SUBJECT: SOURCE RANGE MONITOR MINIMUM COUNT RATE FOR STARTUP
(TAC NOS. 69296 AND 69297)

RE: PEACH BOTTOM ATOMIC POWER STATION, UNIT NOS. 2 AND 3

AMENDMENT TO FACILITY OPERATING LICENSE

SAFETY EVALUATION BY THE OFFICE OF NUCLEAR REACTOR REGULATION SUPPORTING

SRM Count Rate Versus
Signal-to-Noise Ratio

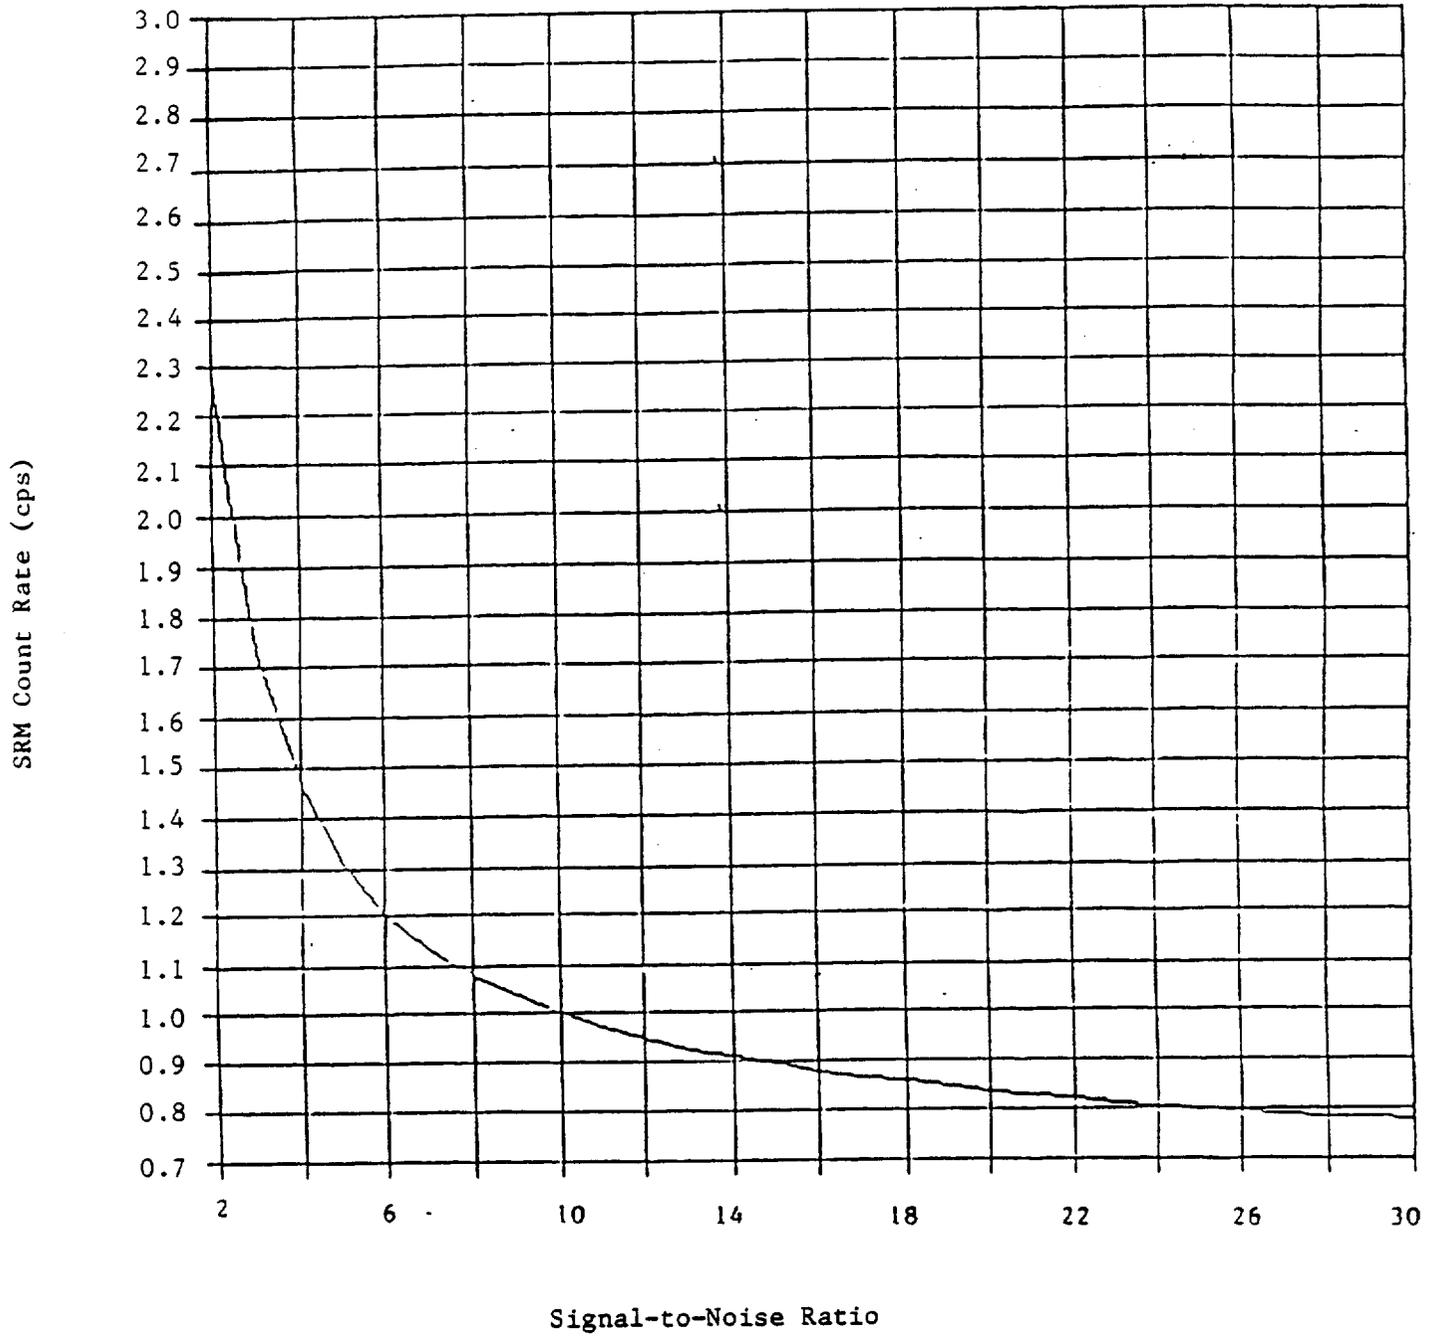
*May be reduced for startup only, provided at least three source range channels have an observed count rate and a signal-to-noise ratio on or above the curve shown on Figure 3.3.1.

The requirement of at least 3 counts per second (may be reduced for start-up provided the count rate and signal-to-noise ratio is on or above the curve shown on Figure 3.3.1) assures that any transient, should it occur begins at or above the initial value of 10^{-8} of rated power used in analyses of transient cold conditions. One operable SRM channel would be adequate to monitor the approach to criticality using homogeneous patterns of scattered control rod withdrawal. A minimum of two operable SRM's are provided as an added conservatism.

The proposed changes are to TS 3/4.3.B.4 and associated Bases. The changes add, via an asterisk marked footnote, a statement that the 3 cps requirements may be reduced for startups if three (vs two for the current specification) SRM Channels meet the limits on count rate vs S/N ratio provided in proposed TS Figure 3.3.1. As an example, a count rate of 0.8 cps is allowed if the S/N ratio is about 25 or more. Figure 3.3.1 is based on the new analysis by GE for PB2&3 of SRM downscale nominal trip setpoint vs S/N ratio.

The review thus concludes that the proposed change to PB2&3 TS 3/4.B.4 (and Bases), providing an alternate limit for control rod withdrawal during startup when at least three SRM meet the limit of Figure 3.3.1, is acceptable. This approval is specific to the Peach Bottom units.

SRM Count Rate Versus
Signal-to-Noise Ratio

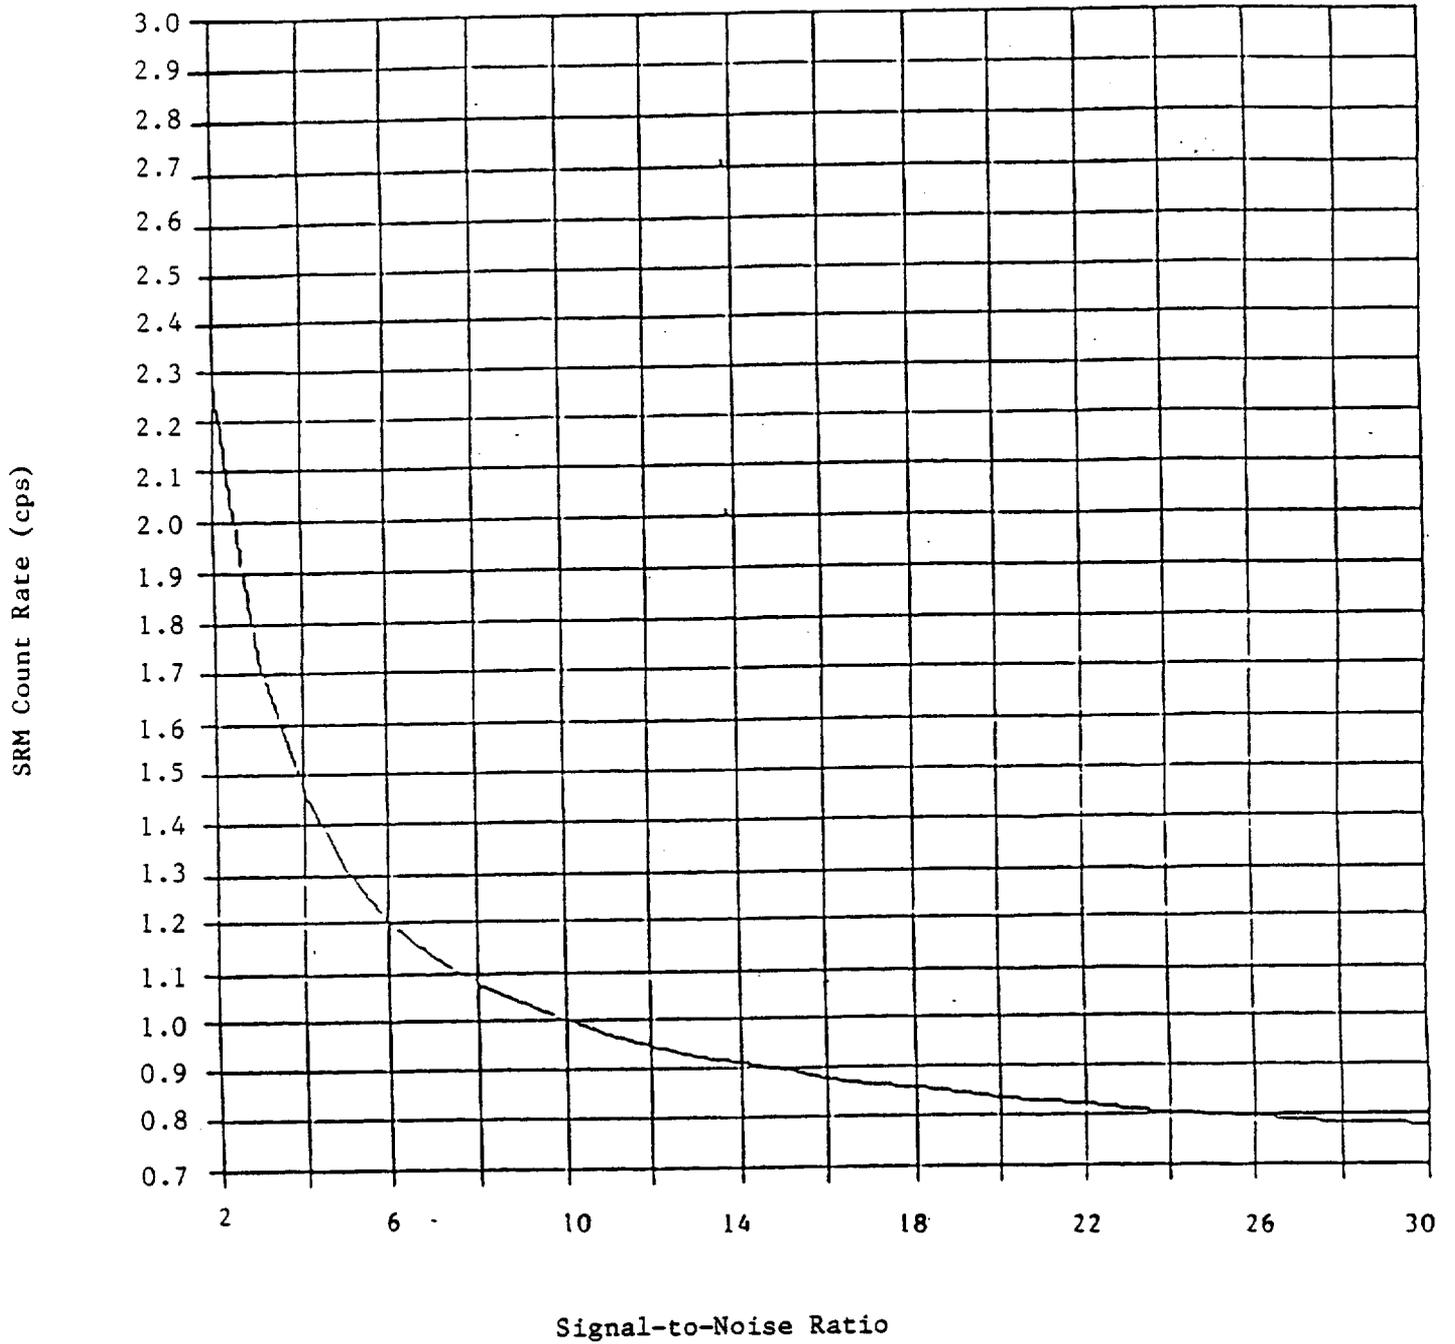
*May be reduced for startup only, provided at least three source range channels have an observed count rate and a signal-to-noise ratio on or above the curve shown on Figure 3.3.1.

The requirement of at least 3 counts per second (may be reduced for startup provided the count rate and signal-to-noise ratio is on or above the curve shown on Figure 3.3.1) assures that any transient, should it occur begins at or above the initial value of 10^{-8} of rated power used in analyses of transient cold conditions. One operable SRM channel would be adequate to monitor the approach to criticality using homogeneous patterns of scattered control rod withdrawal. A minimum of two operable SRM's are provided as an added conservatism.
